### APPEAL SUMMARY

**Appeal ID:** 19041

**Project Address:** 631 SE Taylor St

**Building/Business Name:** The Rose Apartments

GA2

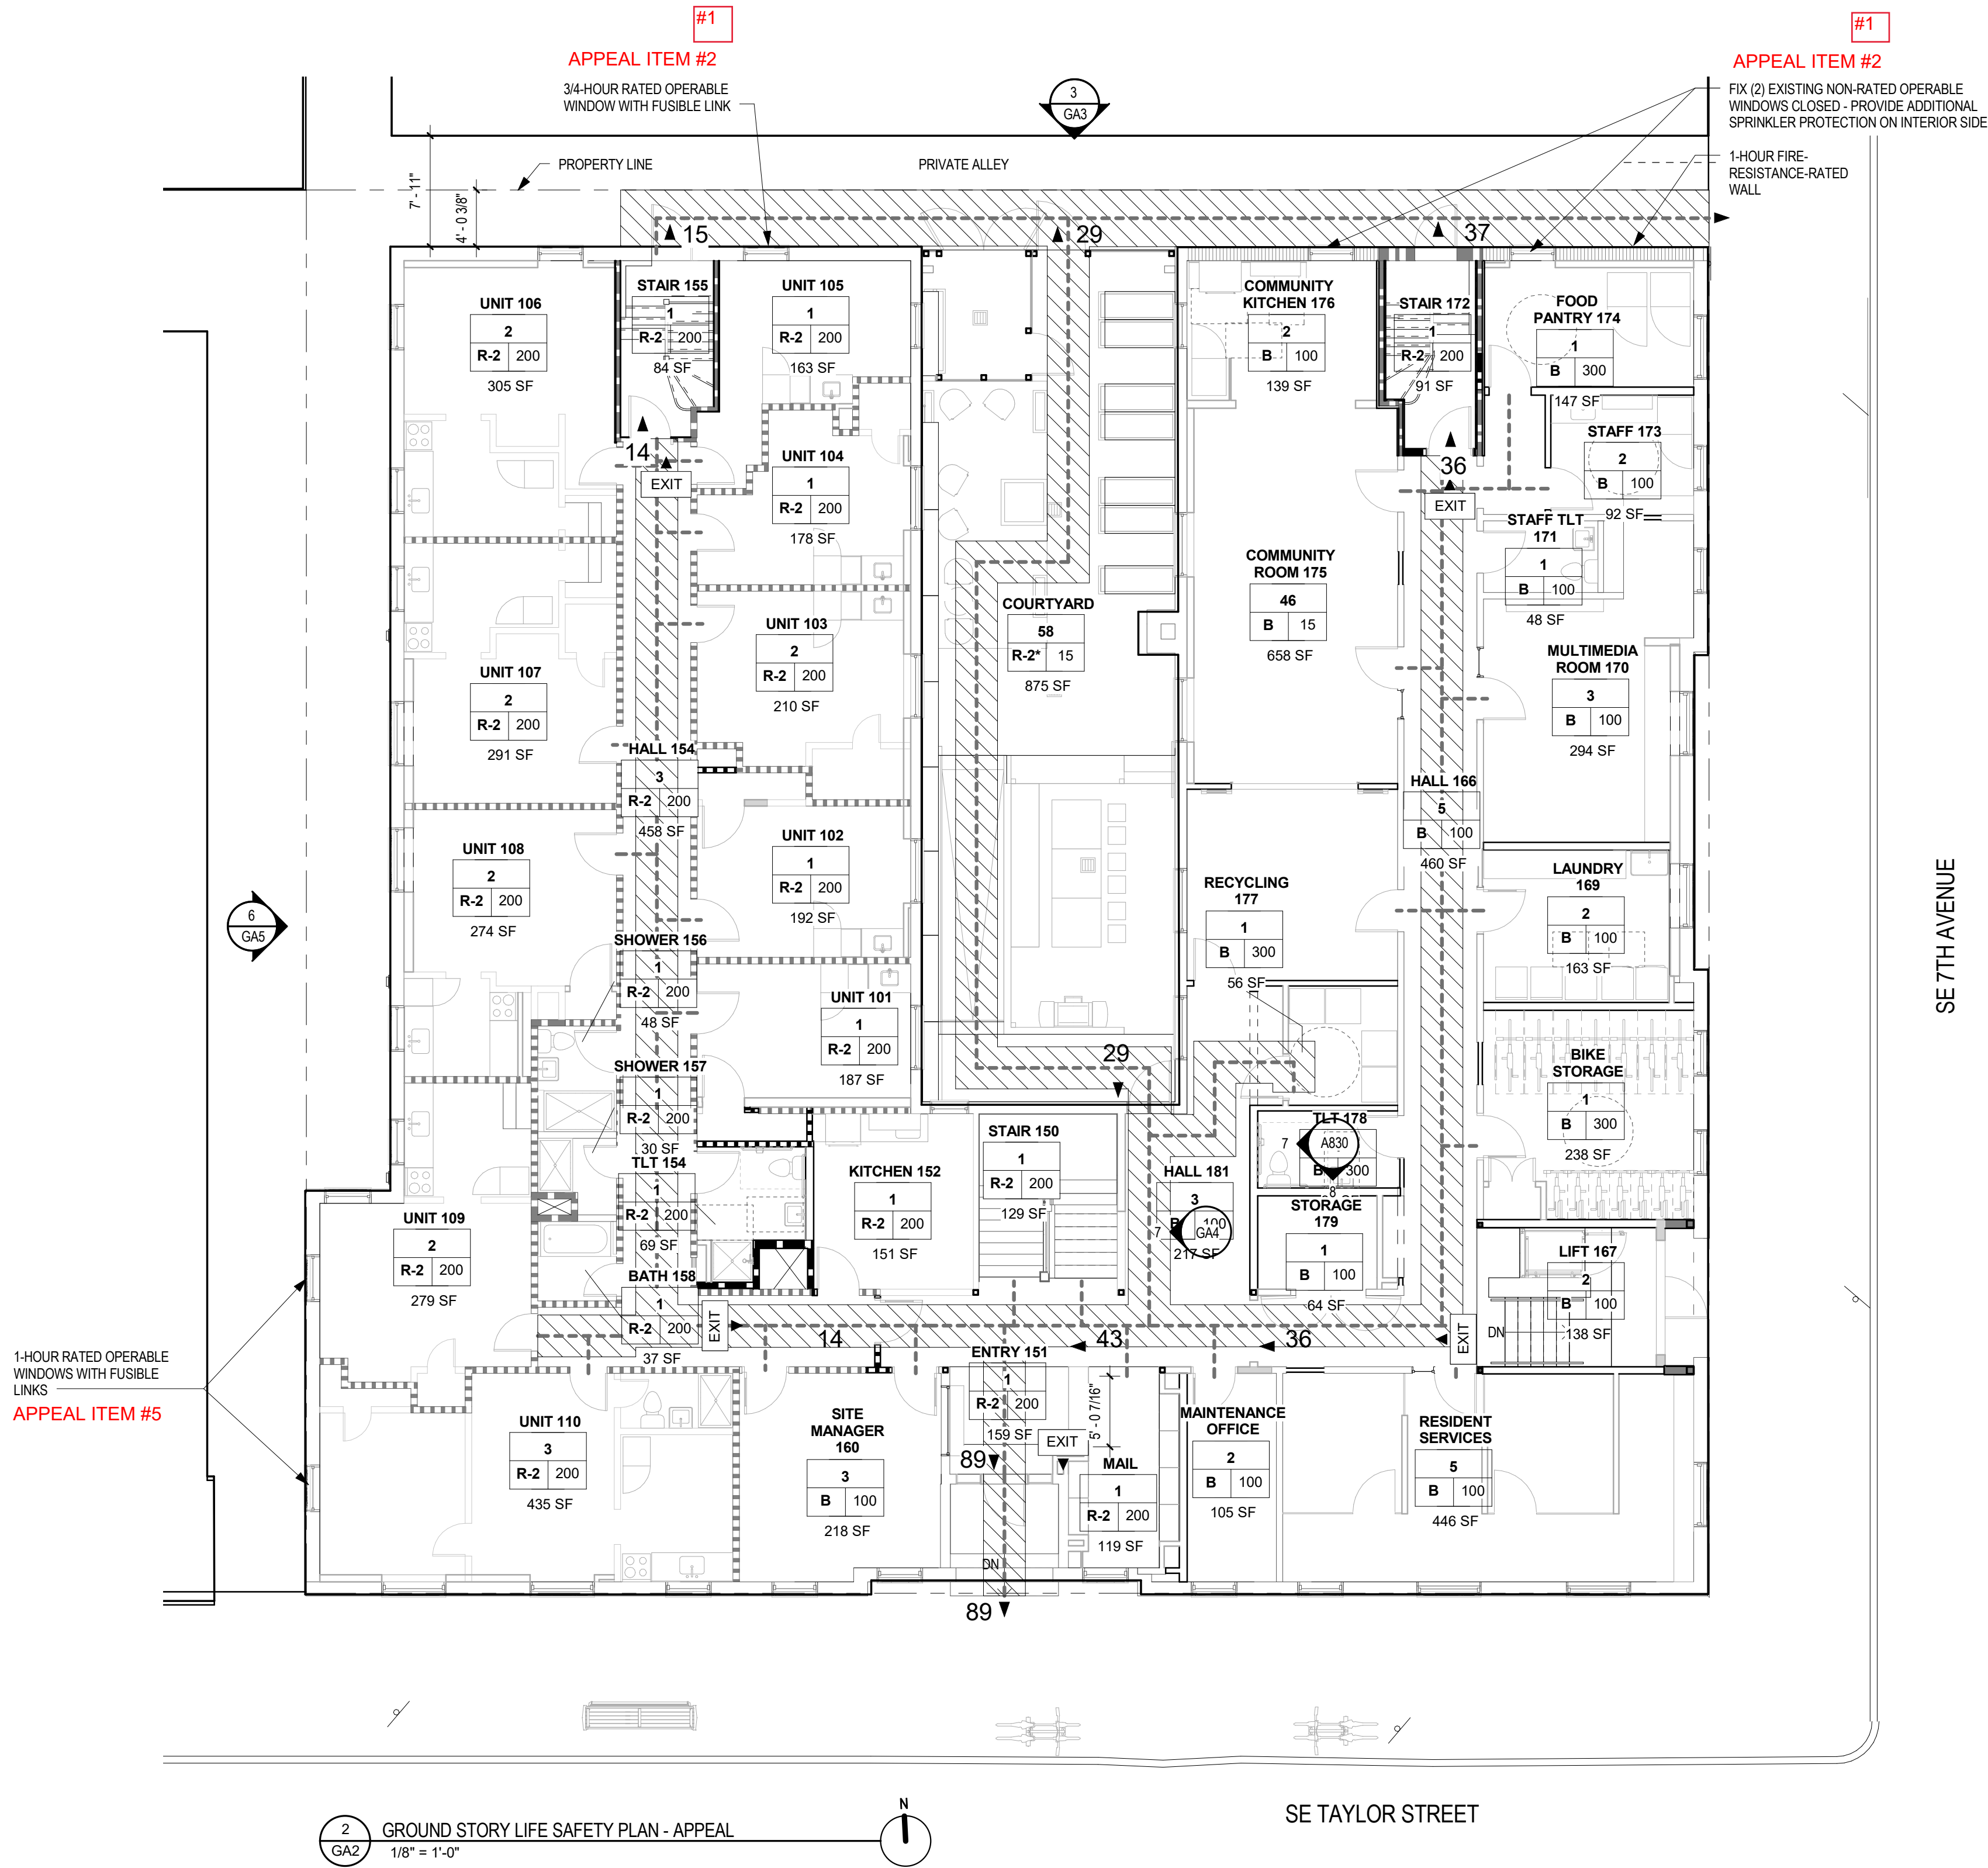
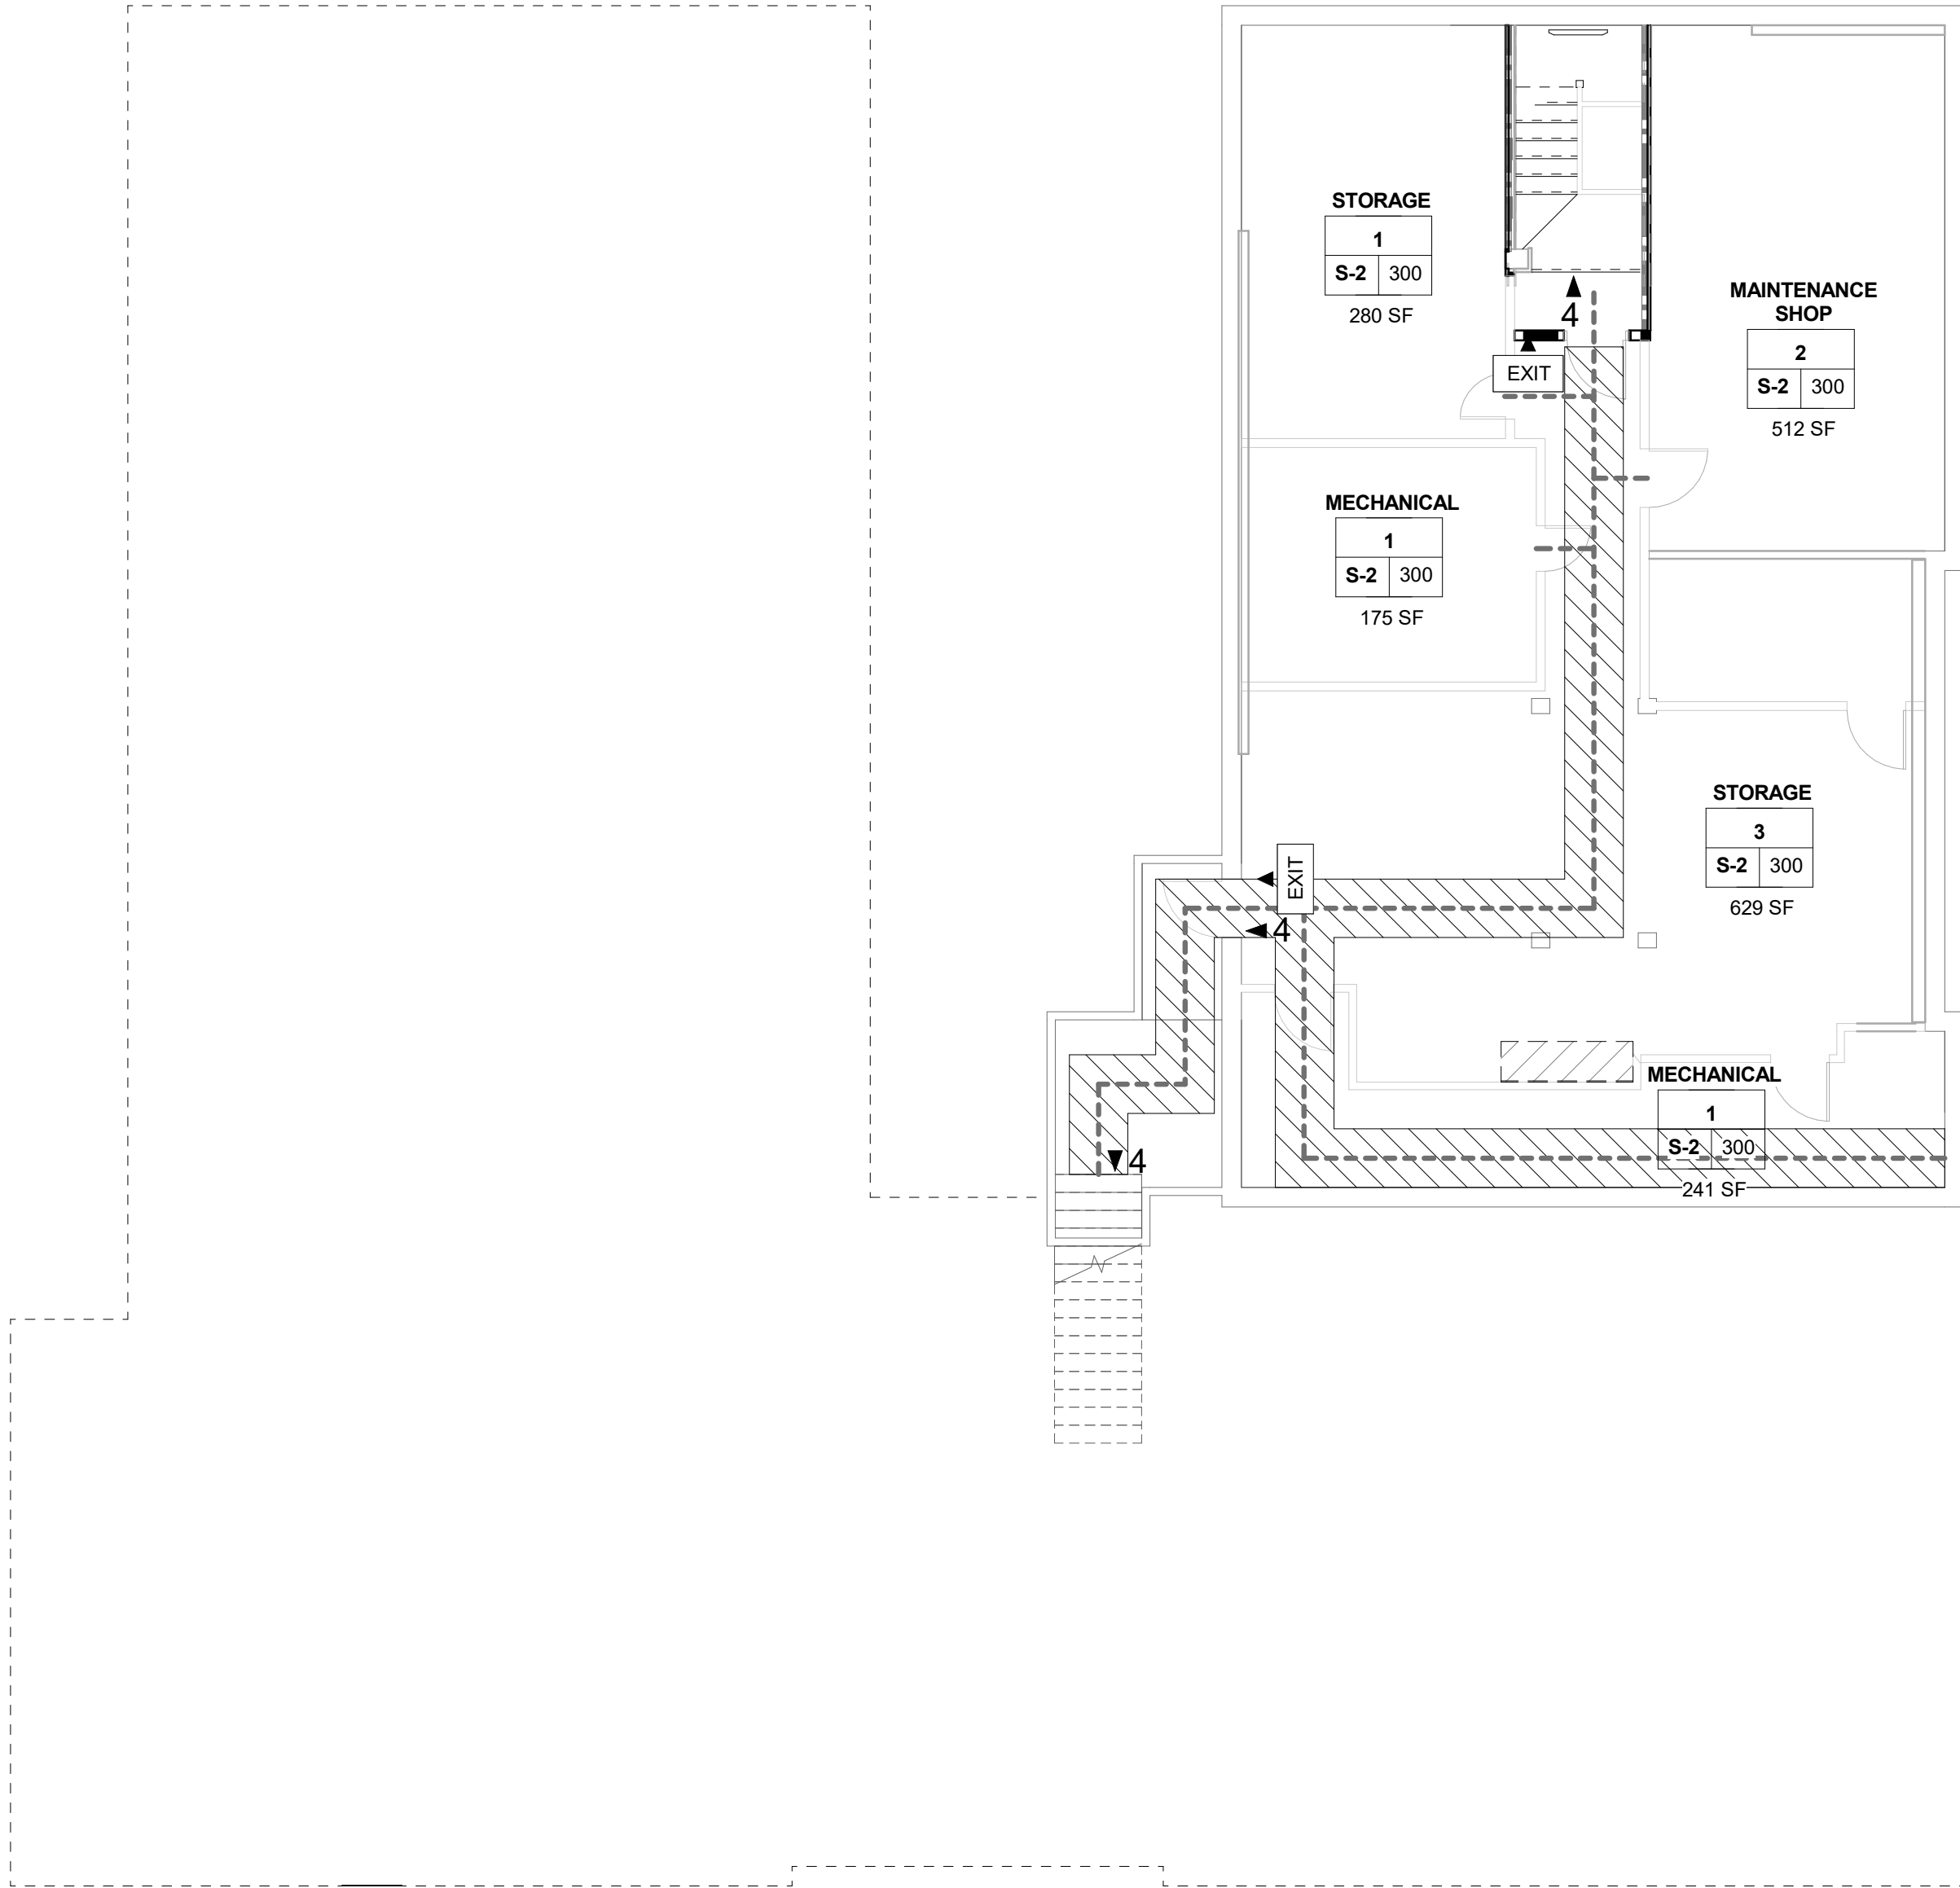
The existing north stairs exit to a private alley that leads to the public way. The alley is not a public way; it is on private property, as shown on Sheet GA2. It is approximately 8' wide, as shown on Sheet GA2. The property line runs down the middle of the alley. 4'-0" of the alley is on this project's site with the remaining 4' on the adjacent building's site, as shown on Sheet GA2.

There is one existing ground story non-rated operable window along the western portion of the egress court (Unit 105). This window was approved by Appeal #6358. This window will be replaced with a UL listed ¾-hour fire-rated operable window with a fusible link that closes the window in the event of a fire. There are two existing ground story non-rated operable windows along the eastern portion of the egress court (Kitchen 124 and Food Pantry 123). These windows were approved by Appeal #6358. These windows will remain and be fixed in place, with additional sprinkler protection provided on the interior side. See Sheets GA2 and GA3.

**1. Type 13 water curtain sprinkler protection at non-fire rated openings in exterior walls of egress court less than 10' in width: Granted provided windows are non-operable and sprinklers are spaced not more than 6 feet apart and placed a minimum of 6 inches and a maximum of 12 inches from the opening(s) and a maximum of 12 inches below the ceiling. Sprinklers are to be installed on the occupied side of the openings. A separate permit from the Fire Marshal's Office is required.**
